Project # 25036 (MKM), 2509-276 (Hafer) – EVPL Red Bank Library
New Construction / 120 S. Red Bank Road, Evansville, IN 47712

ADDENDUM No. 2

June 24, 2026

DRAWING CONTENTS:
SITE MATERIALS PLAN

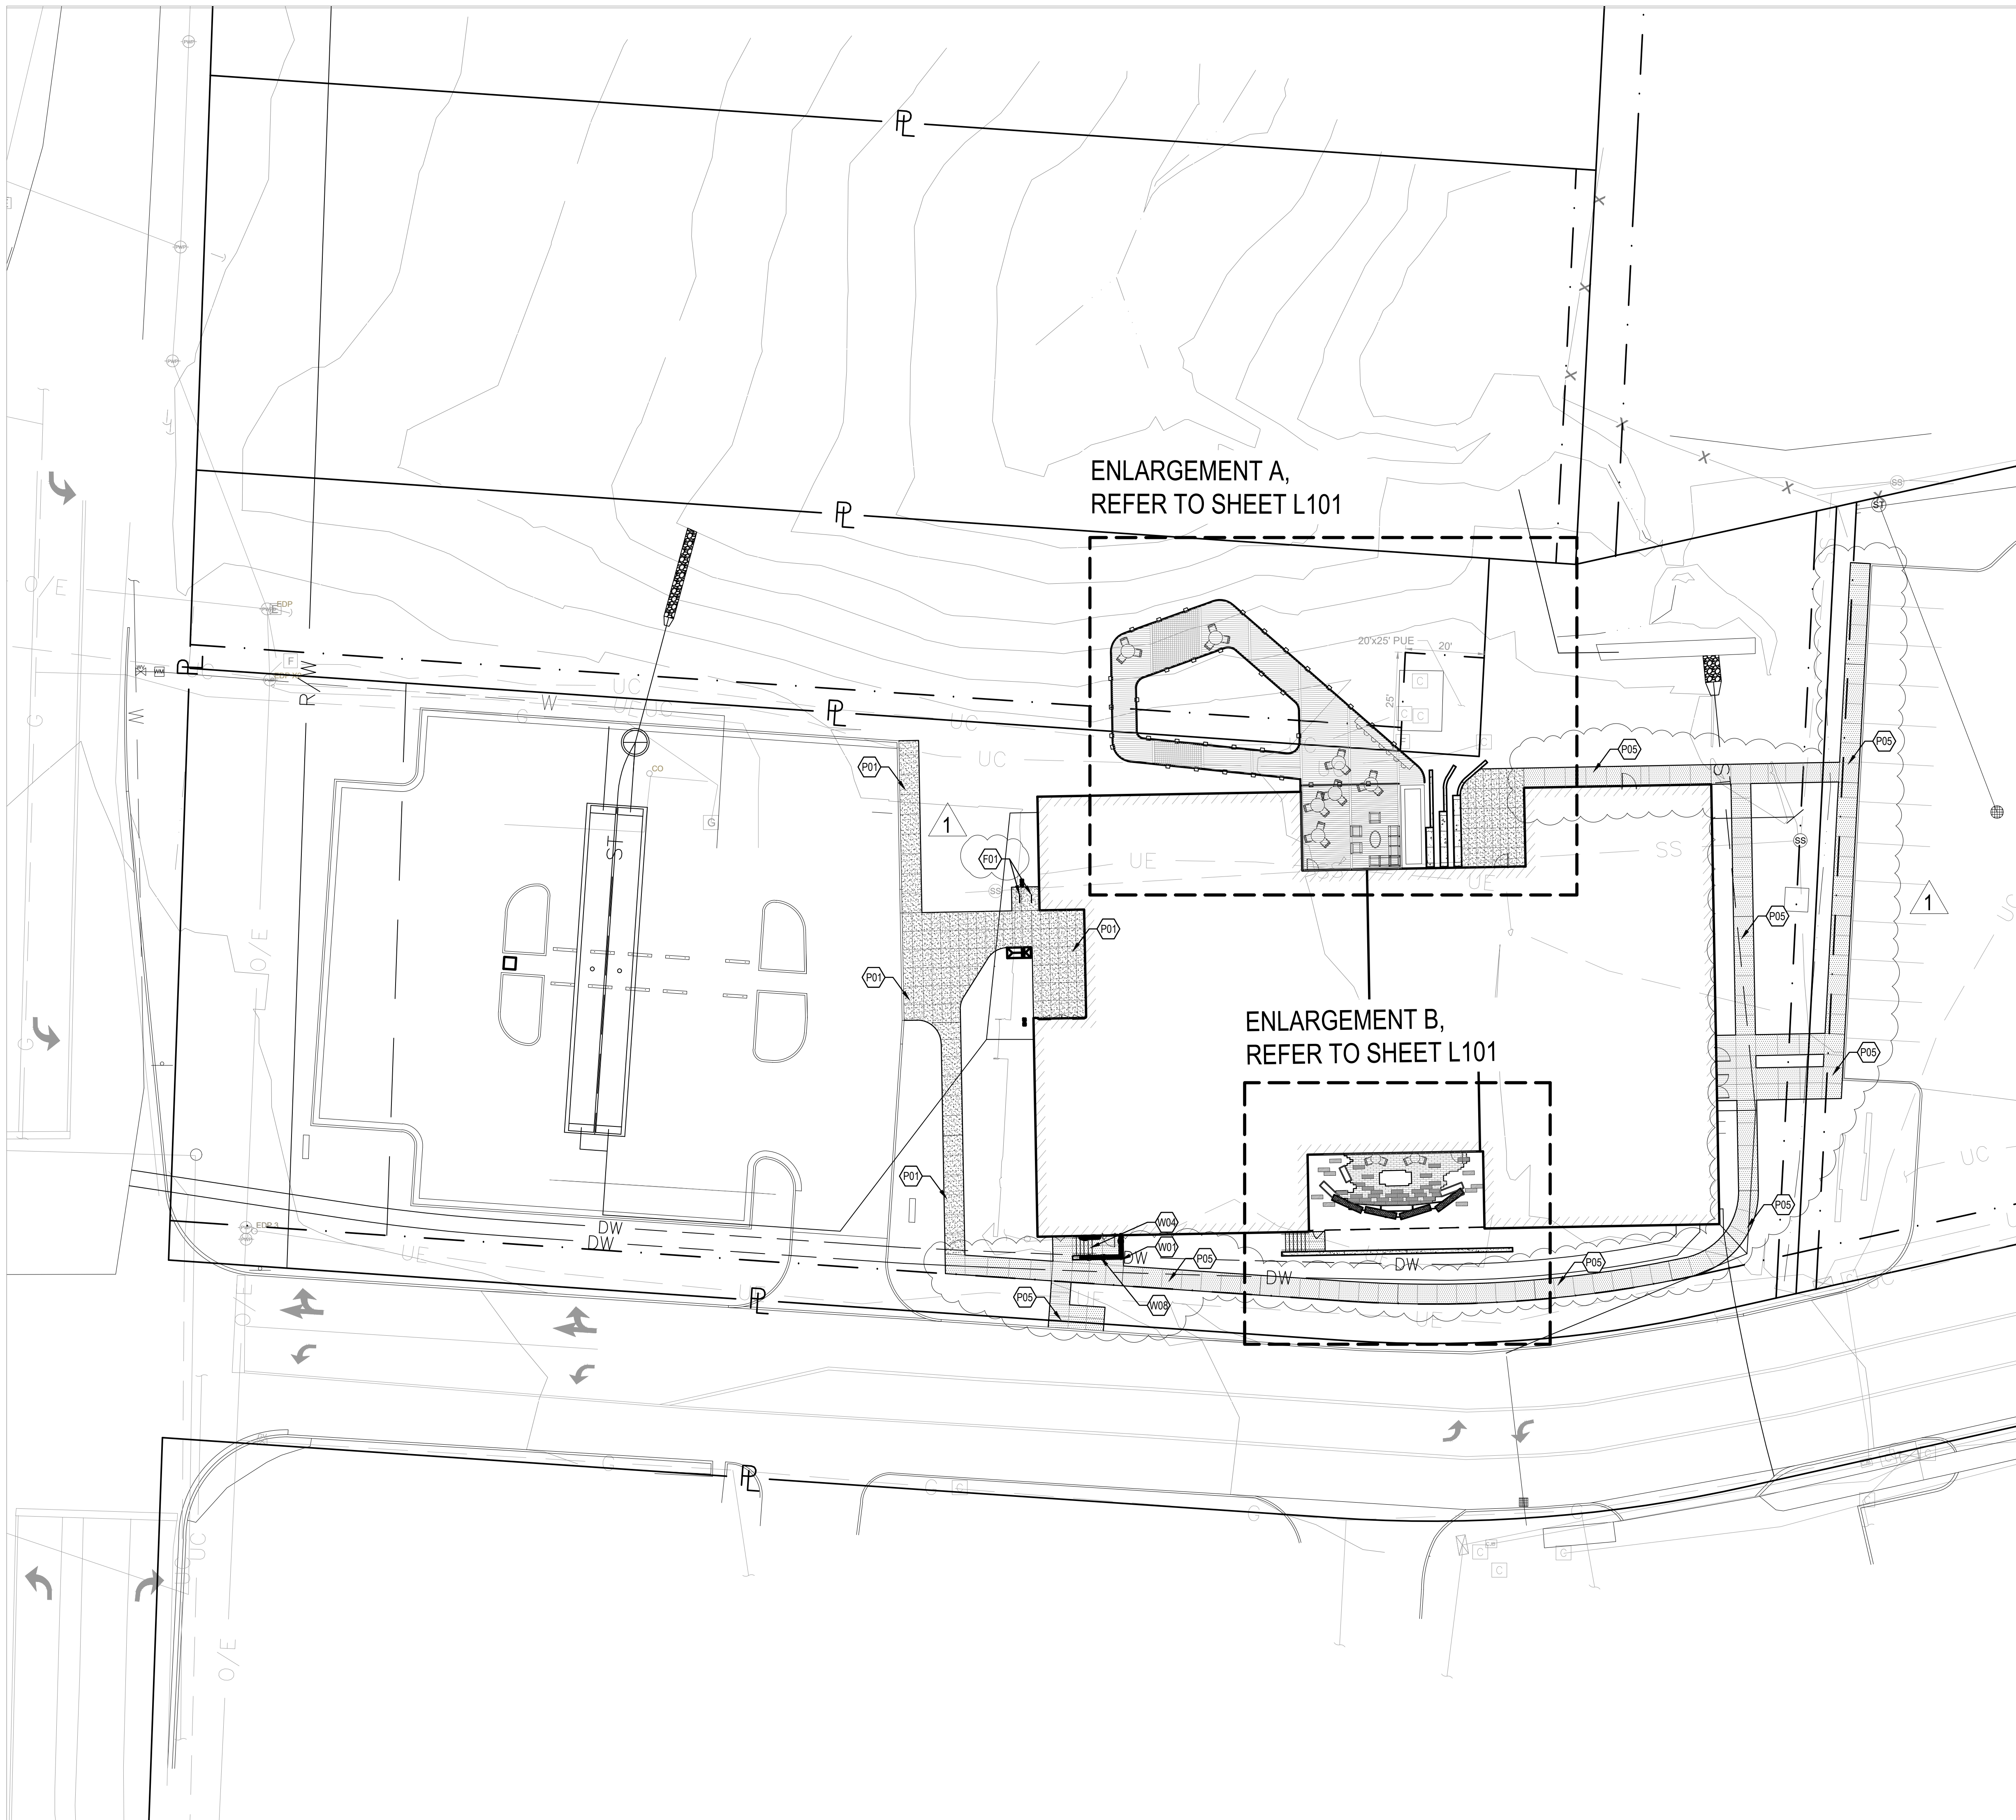
- ff. Answer: Missing details for the deck and railing are forthcoming via addendum 3.
- gg. Question: Referencing note W09 on sheet L-100, please provide further details for bar ledge & stools.

- i. Addition: Added Sections 11 through 17
- i. **Sheet S-402 – FRAMING DETAILS**
 - i. Addition: Added Sections 11 and 12
- j. **Sheet L-100 – SITE MATERIALS PLAN**

- i. Clarification: Material legend updated
 - ii. Change: Reduction to area of sand release concrete pavement finish
- k. **Sheet L-101 – SITE MATERIALS PLAN ENLARGEMENT**

- hh. Answer: Missing details for bar ledge and stools are forthcoming via Addendum 3.
- ii. Question: Is millwork base to be installed on circular column covers or standard cove base?

1 DECORATIVE SCREEN
Scale: 1" = 1'-0"

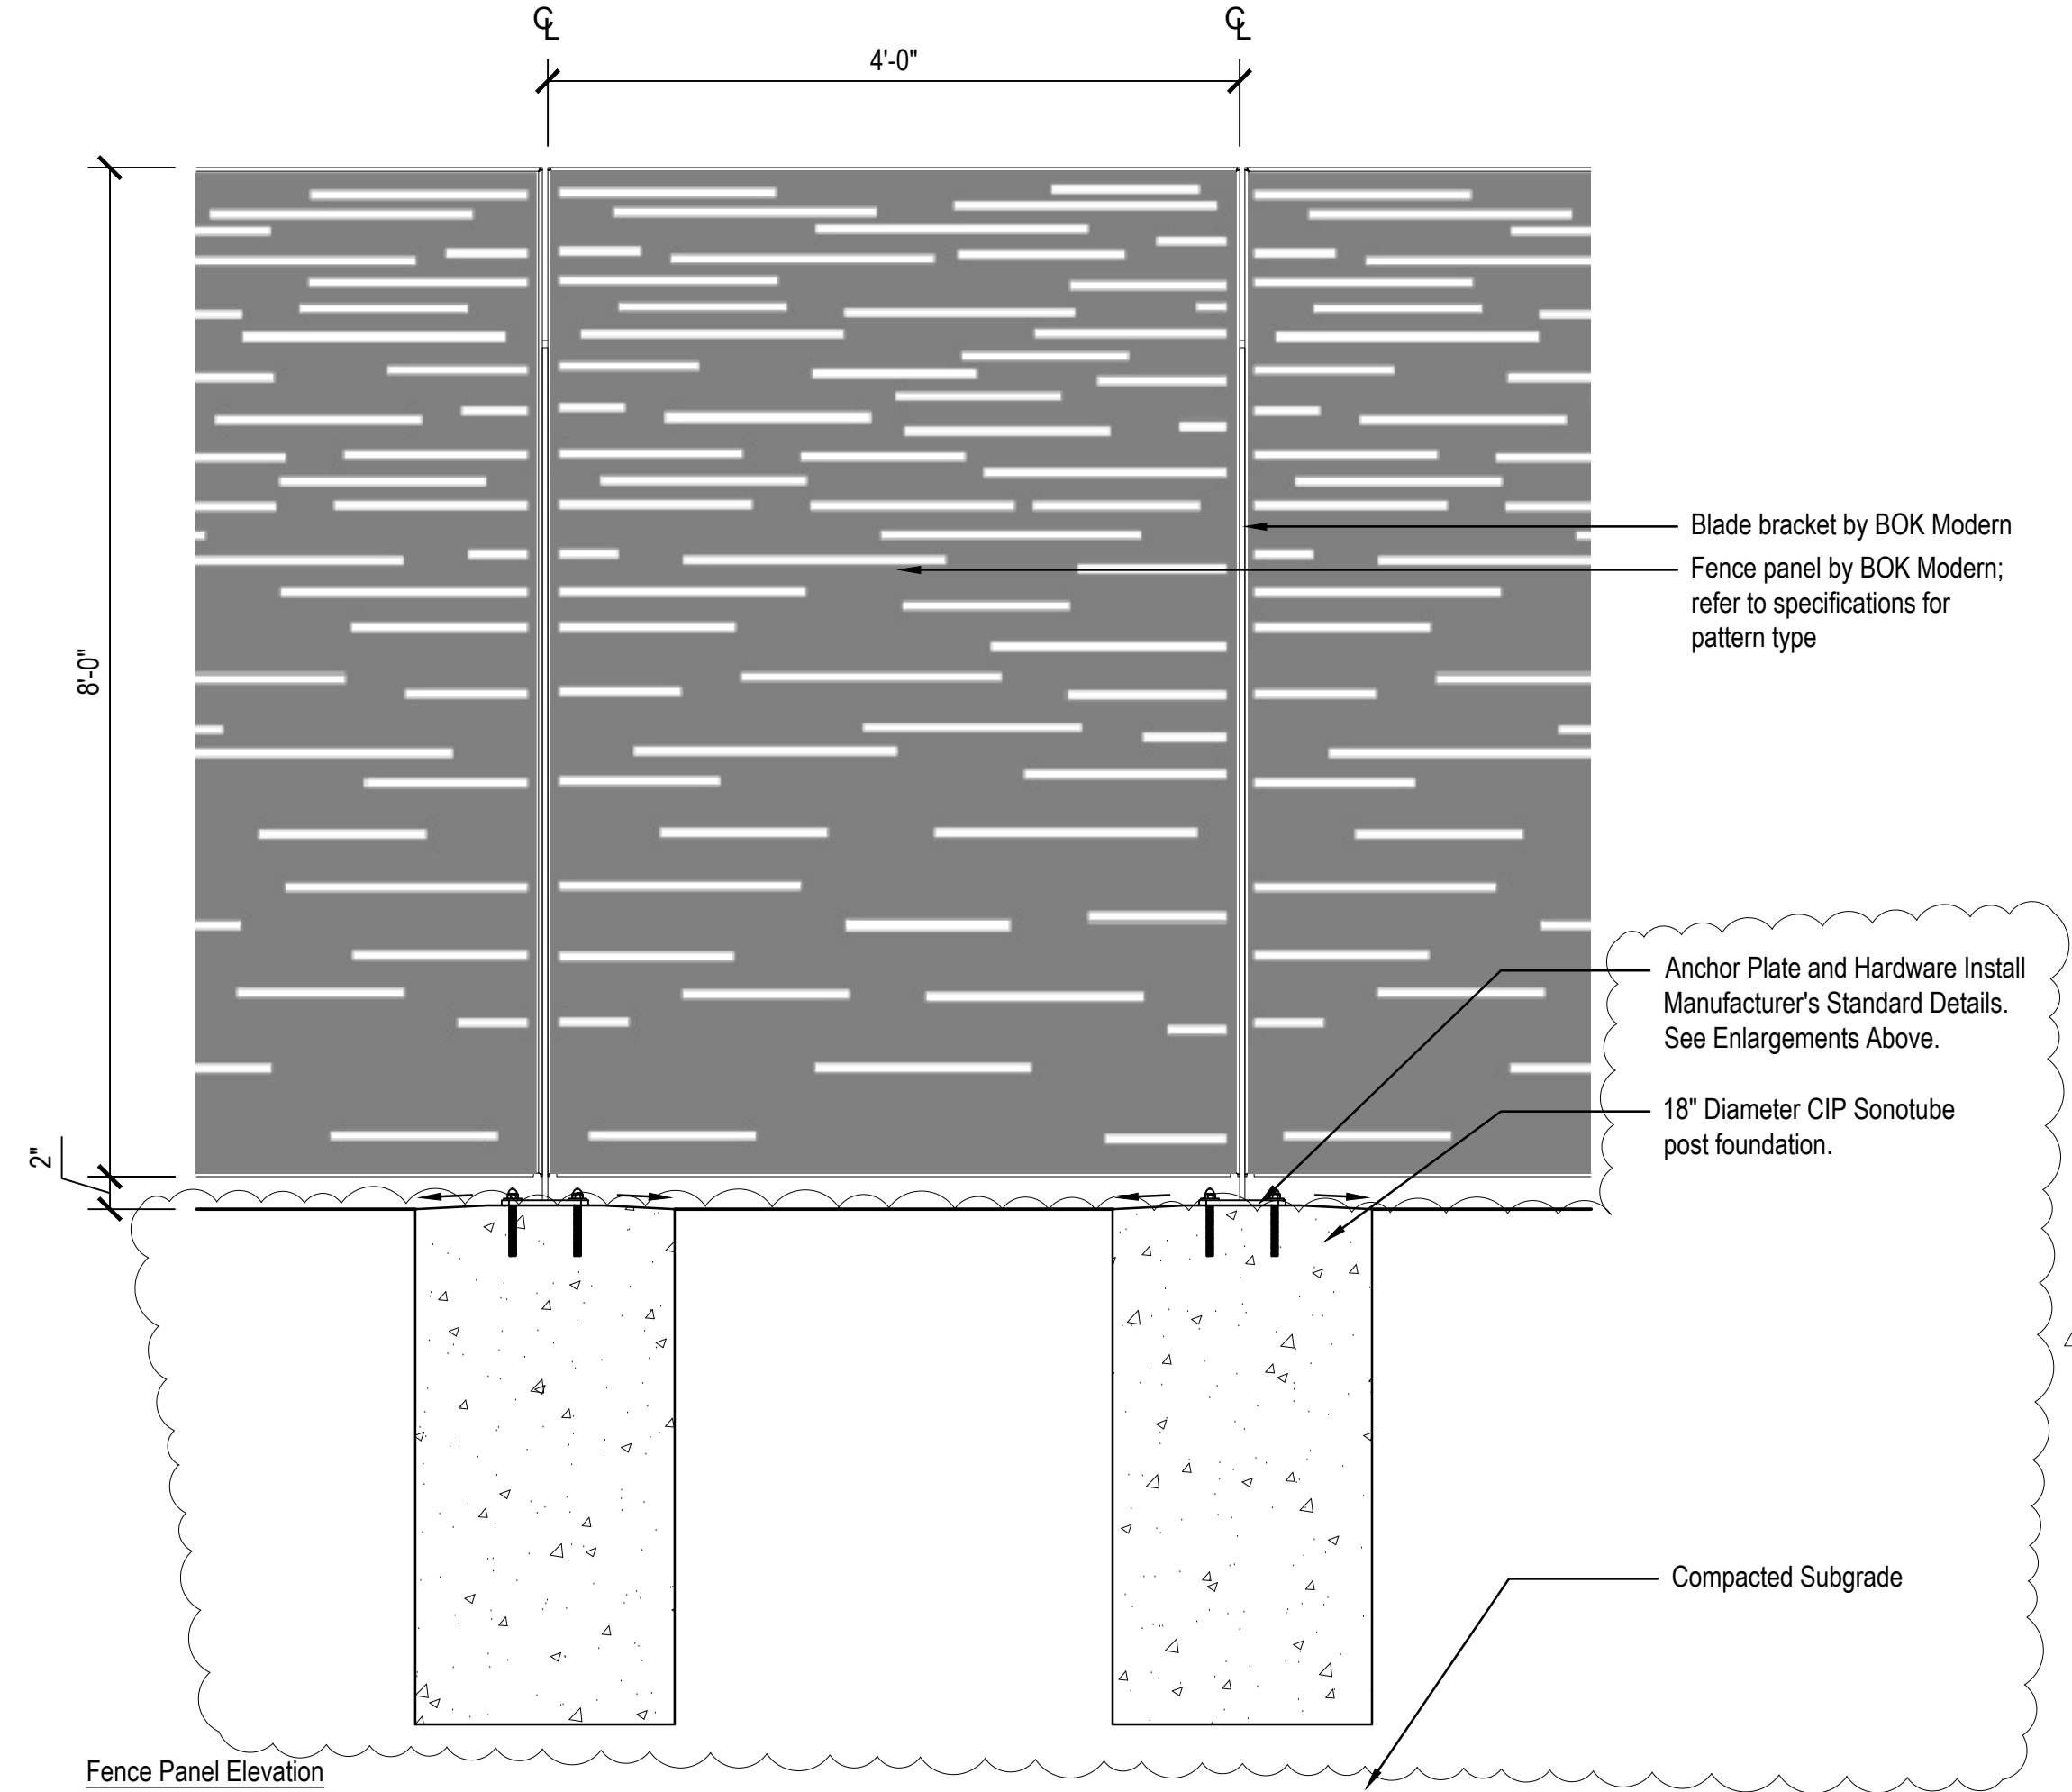
- n. **Sheet L-602 – SITE DETAILS**
 - i. Clarification: updated detail #1 to include clarification to concrete sonotube.
